# UNITED STATES PATENT AND TRADEMARK OFFICE

APPLICATION NO.	FILING DATE	FIRST NAMED INVENTOR	ATTORNEY DOCKET NO.	CONFIRMATION NO.
09/555,899	07/20/2000	STEFAN BRAUCHLE	225/48888	8921
7590 03/04/2004			EXAMINER	
Crowell & Moring, L.L.P. Intellectual Property Group P.O. Box 14300 Washington, DC 20044-4300			DOROSHENK, ALEXA A	
			ART UNIT	PAPER NUMBER
			1764

# Office Action Summary

## **DETAILED ACTION**

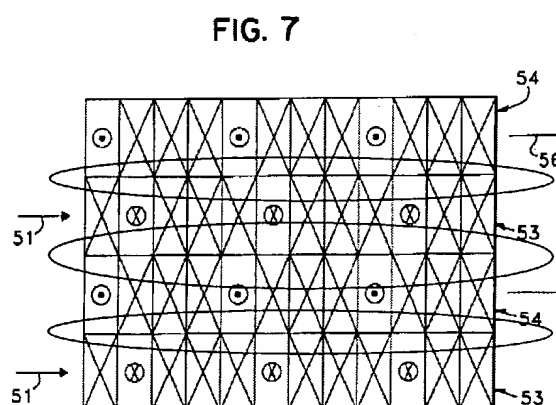
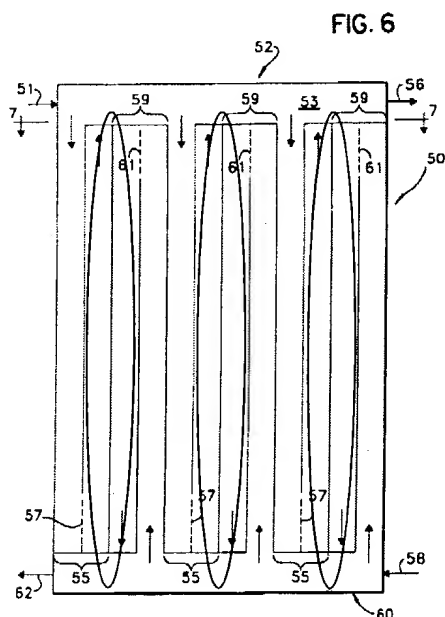
a plurality of reaction chambers (59) with catalyst (col. 3, lines 10-14) and a plurality of cooling chambers (55) (col. 9, lines 10-14) wherein said chambers are formed between successive plates and defining at least two stages in a plate stack (fig. 6 and col. 8, line 58- col. 9, line 14);

wherein said plates have openings that form inlet or outlet channels for the reaction chambers (61) and the cooling chambers (51);

wherein the reaction chambers (59) are each connected exclusively to inlet (58) and outlet (62) channels for the gas flow;

wherein the cooling chambers (55) are each connected exclusively to inlet (51) and outlet (56) channels for the coolant flow;

separating plates (shown as 22 in figure 2, but not numbered in figures 6 and 7, the separating plates are circled in the figures of Romatier below) arranged between at least two successive stages; and

a first apparatus (58) for supply gas to a first stage.

Romatier does not disclose a second or third apparatus for supplying a gas to at least one other stage following the first stage wherein the second or third apparatus leads into an outlet channel for the gas flow from a preceding stage.
